ALBERT SQUARE PUBLIC REALM
DESIGN UPDATES
03.02.21
PLANIT-IE

OUR
TOWN
HALL
PROJECT

Albert Square
Proposed GA - updates to tree avenue and tree numbers

Plan showing UU trunk main and tree pit offsets

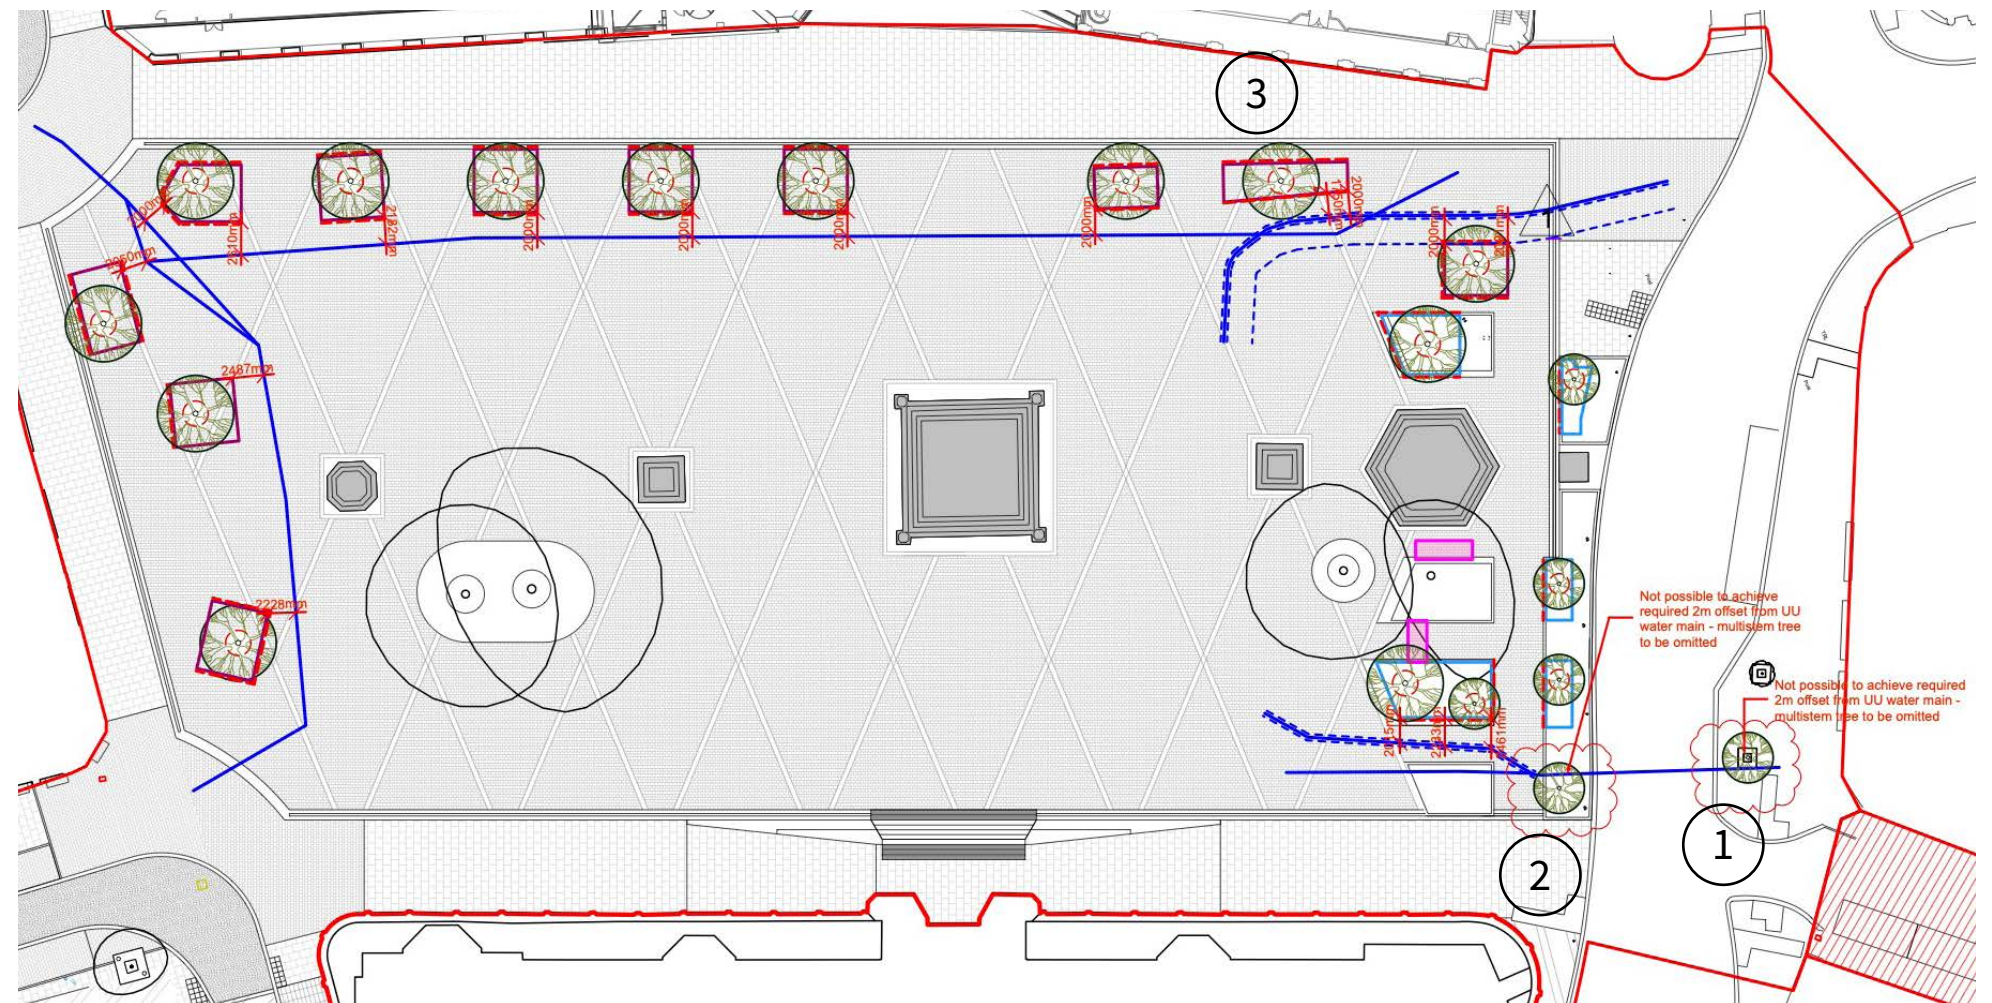
- It has been possible to achieve this offset requirement in all locations except for three trees as highlighted on the adjacent plan that clash with a UU 500mm trunk main (blue line).

- The first (1) is a proposed replacement for the existing tree on Princess St that has died (outside Piccolino). It was proposed to utilise the existing tree pit in this location however UU have recently advised that they had never approved the original tree planting and will therefore not accept the tree to be replaced in this location.

- The tree (2) proposed in the planter to the Princess St edge of the square is a smaller multistem tree. This tree position has been dictated by the available space between the HVM bollard foundations.

- The tree (3) within the avenue is a large tree that would normally require a 10m offset. It is only possible to achieve a 1.75m offset and UU have rejected this.

- It is proposed to omit trees (1) and (2) from the scheme due to existing constraints (as detailed on the following page), and relocate the tree (3) within the avenue to achieve the required 2m offset.

Arup Proposed Combined Utilities Diversions Plan (yellow highlighting denotes abandoned/diverted utilities)

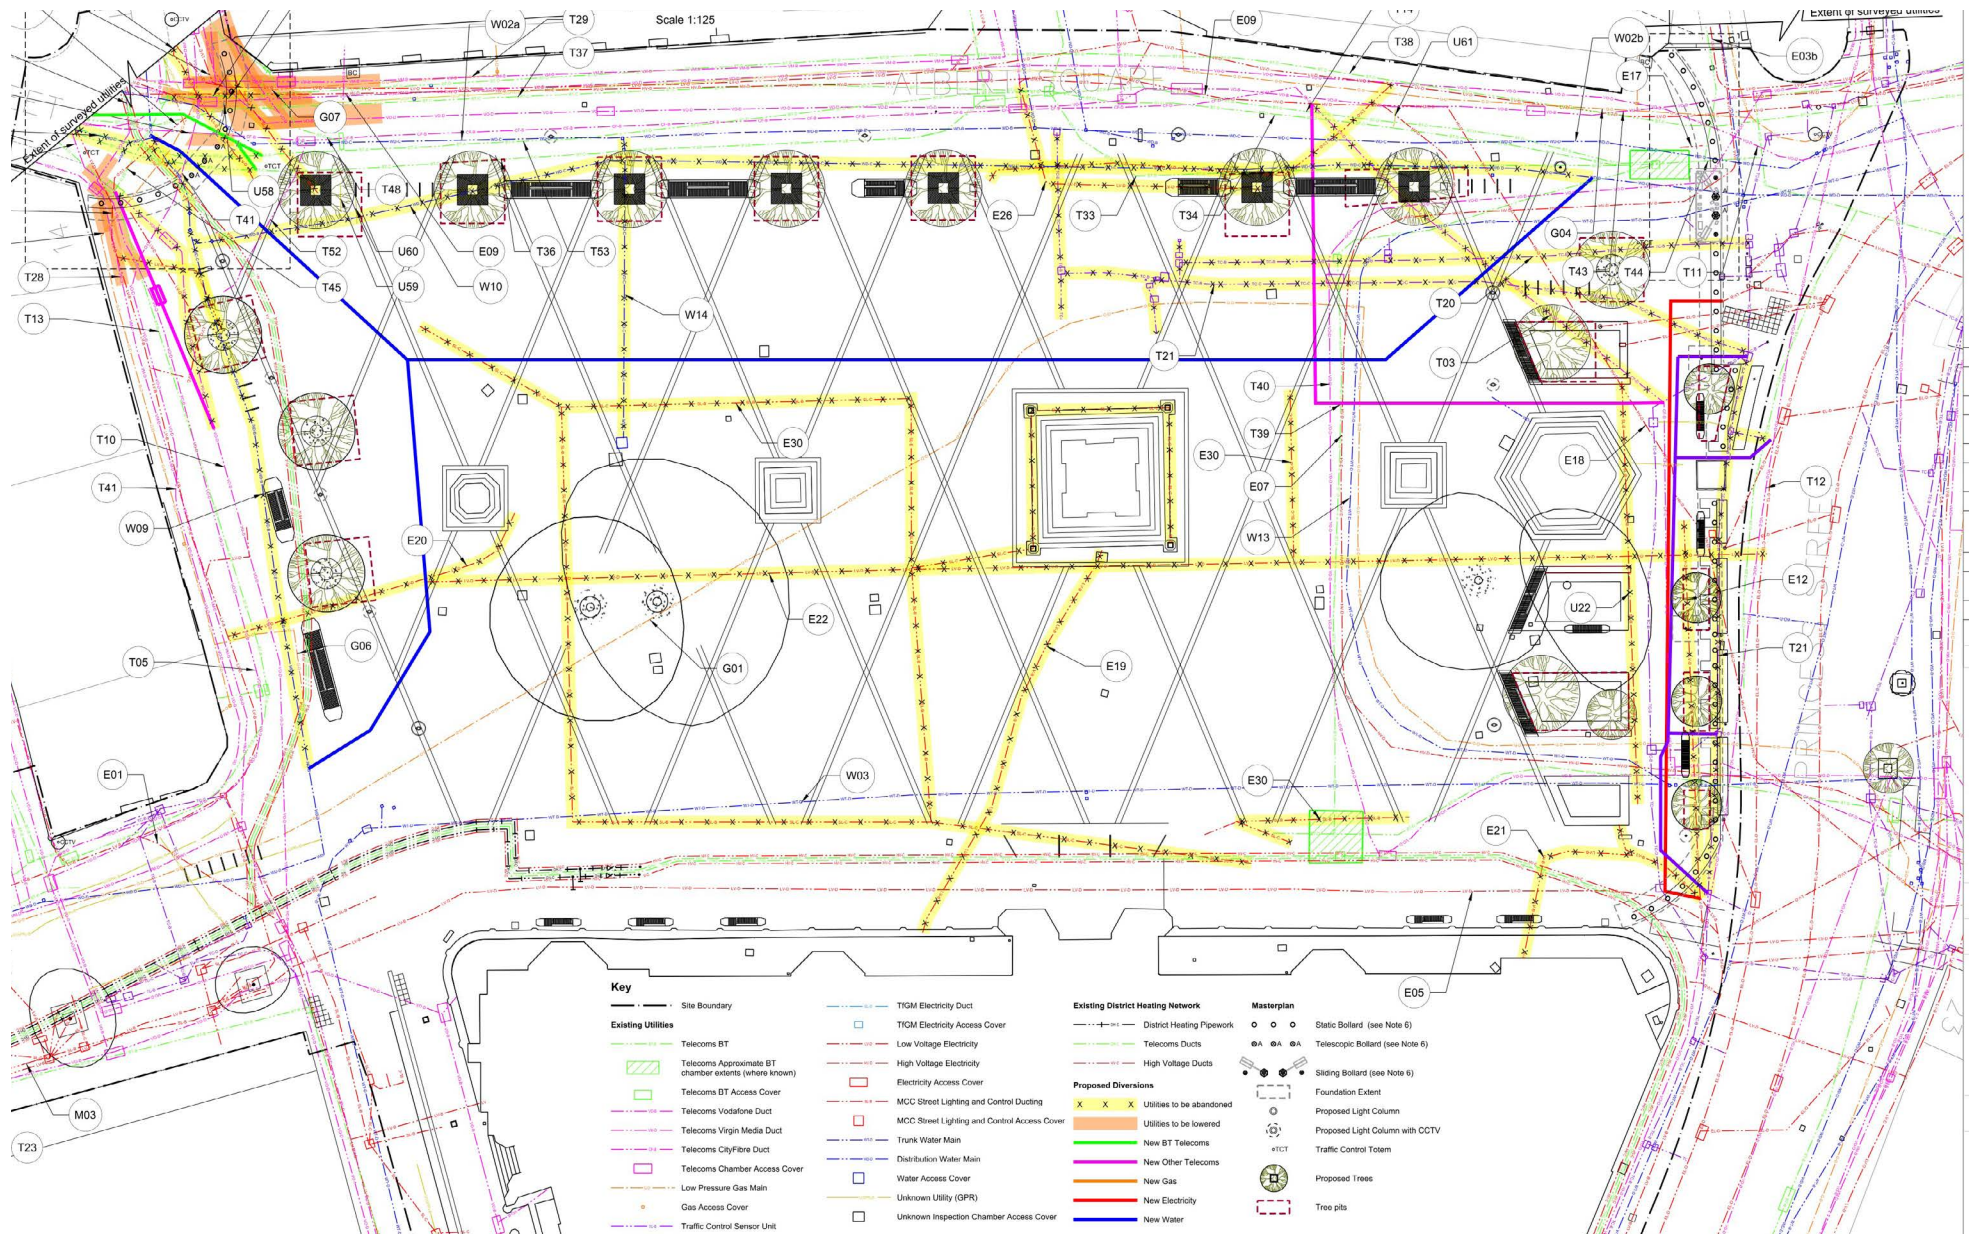
- Albert Square has a significant number of existing utilities and the majority of these run around the edges of the square (where trees are proposed). A large number of utilities are being diverted to accomodate the current proposed trees as can be seen on the adjacent diagram.
- There is also a concentration of utilities at the corners of the square at Mount St, Southmill St, and Princess St.

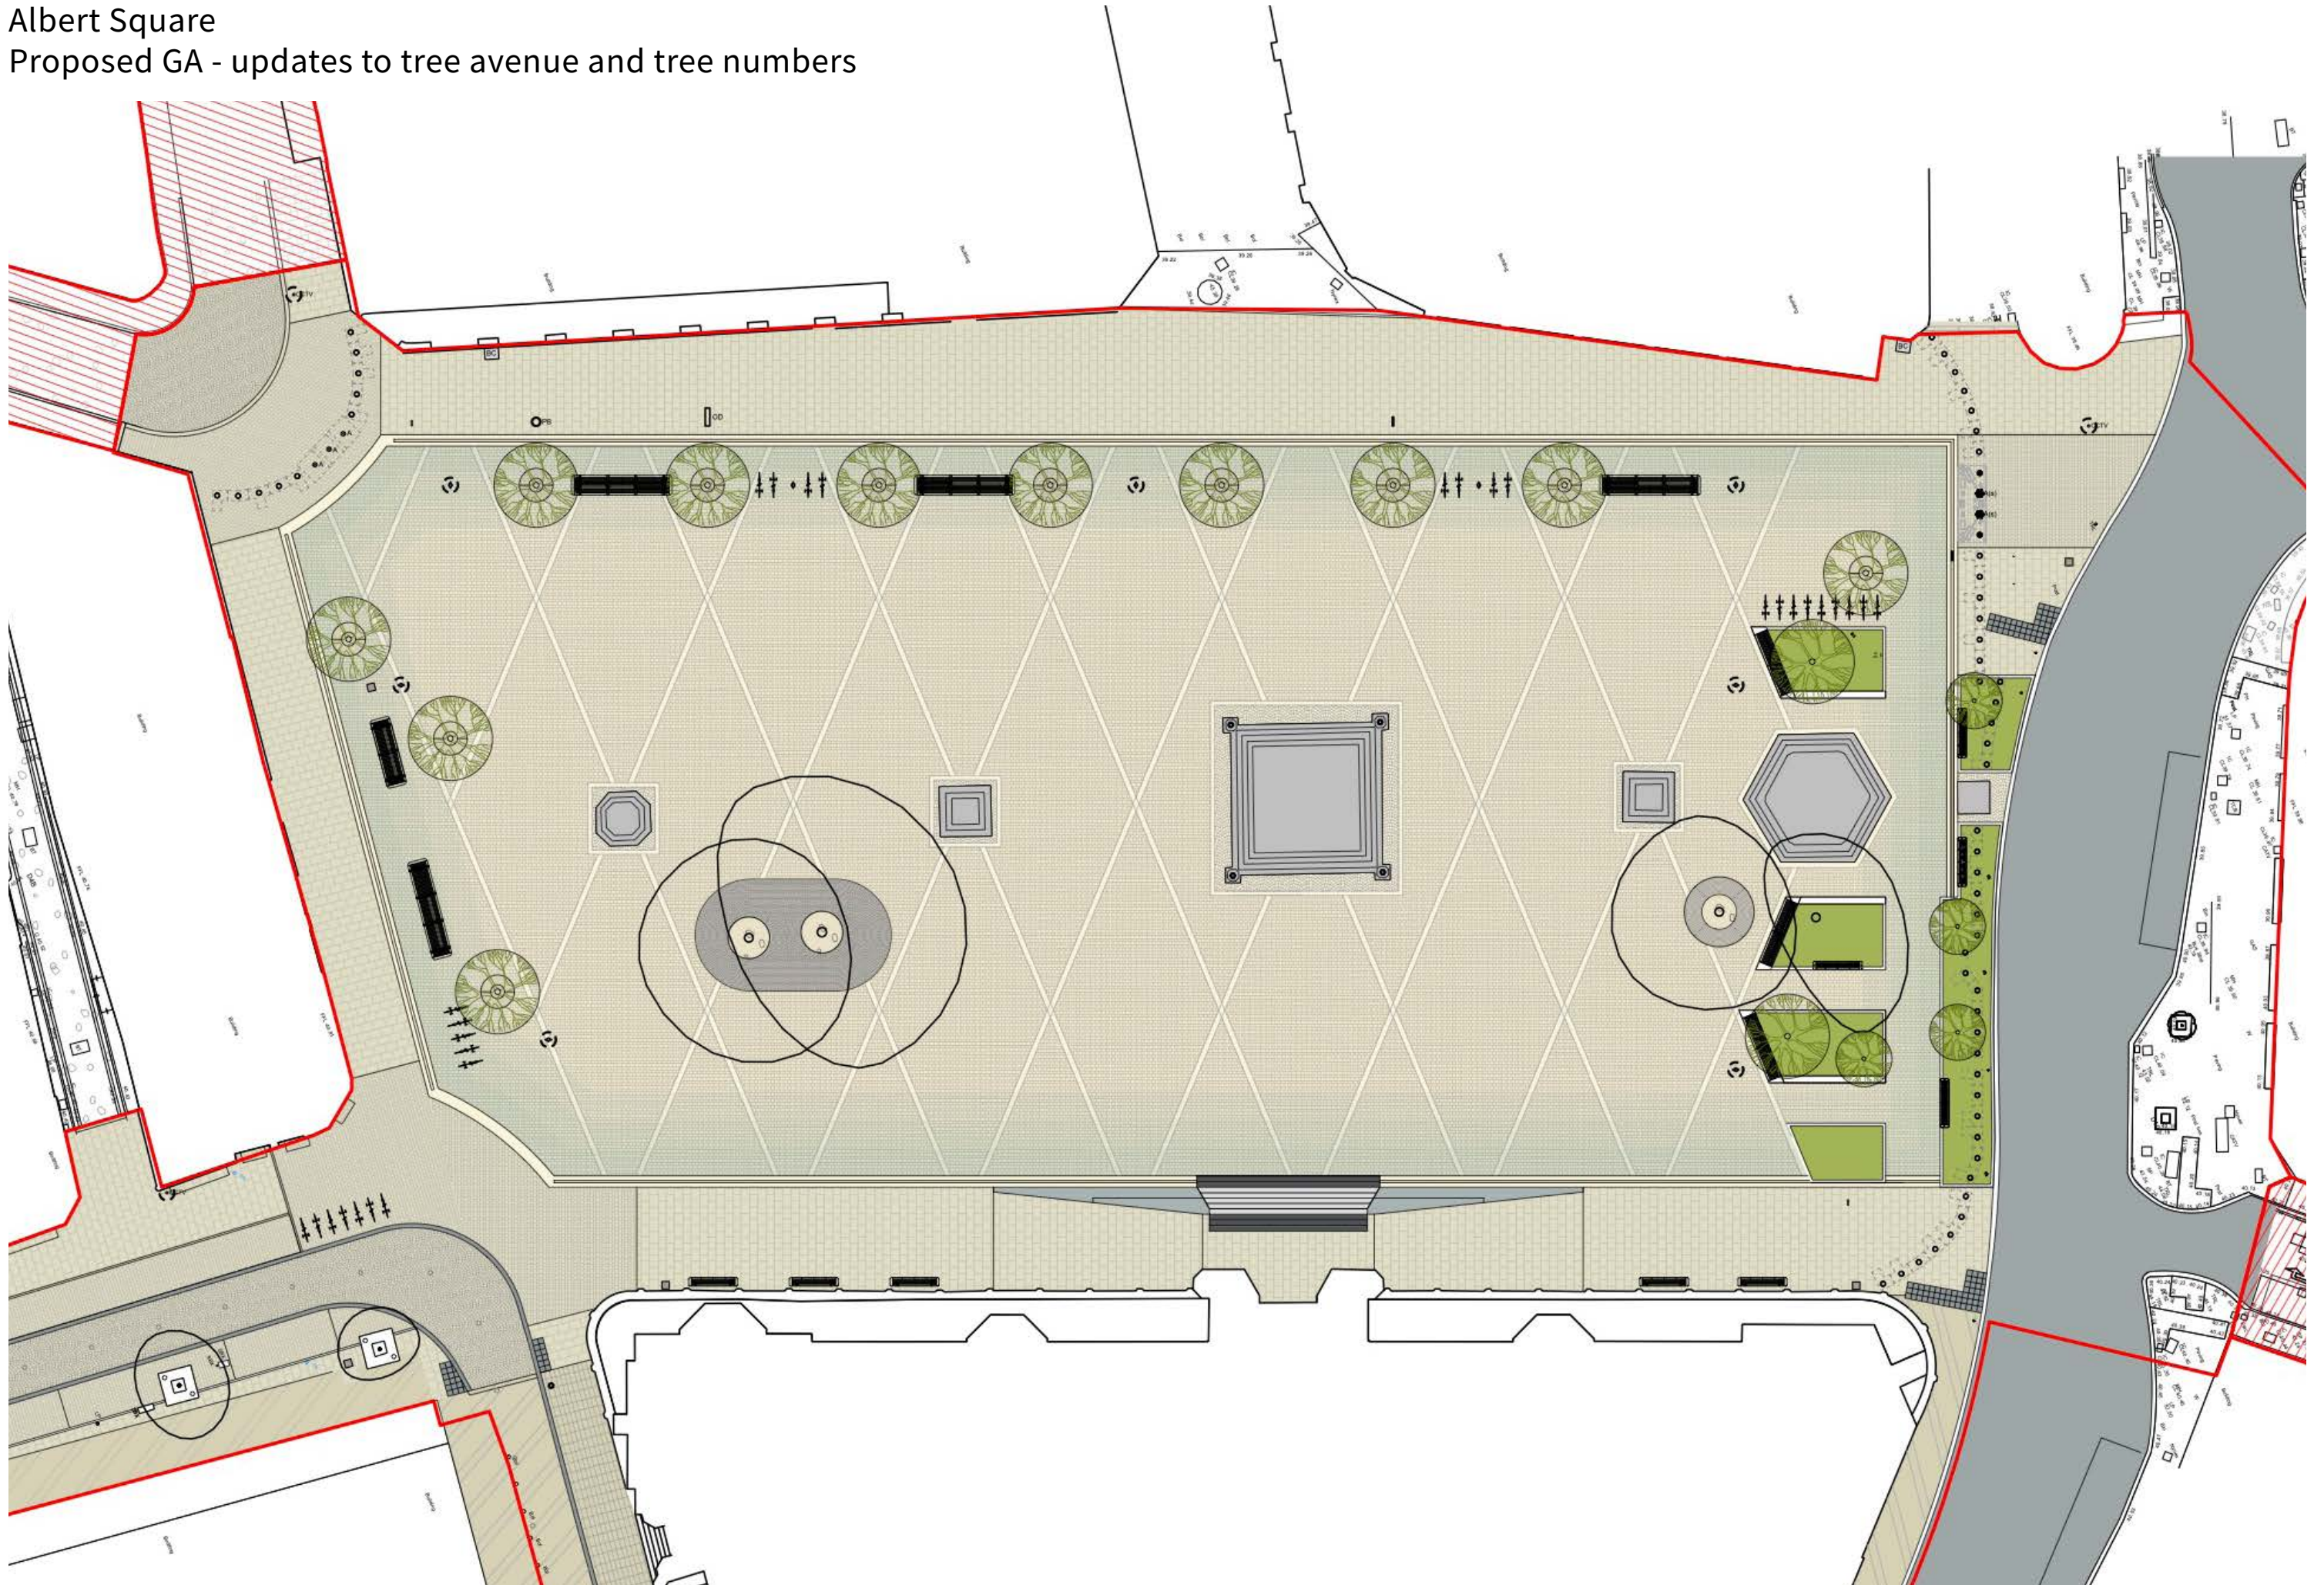
- Abert Square tree avenue has been repositioned to provide a 2m offset between the tree pits and water main as required by United Utilities.
- This includes the repositioning of all 7no trees within the avenue and a minor adjustment to the overall alignment (avenue moved 250mm east towards the square).
- Lighting columns and street furniture positions amended to coordinate with the new tree positions. This includes the omission of 1no small seating plinth due to the constraints of the new layout.
- Omission of 2no trees as unable to provide a 2m offset between tree pits and water main as required by UU. This includes one of the proposed smaller trees within the gardens on Princess St, and the replacement tree on the opposite footway outside Piccolino (Northern Assurance Building).
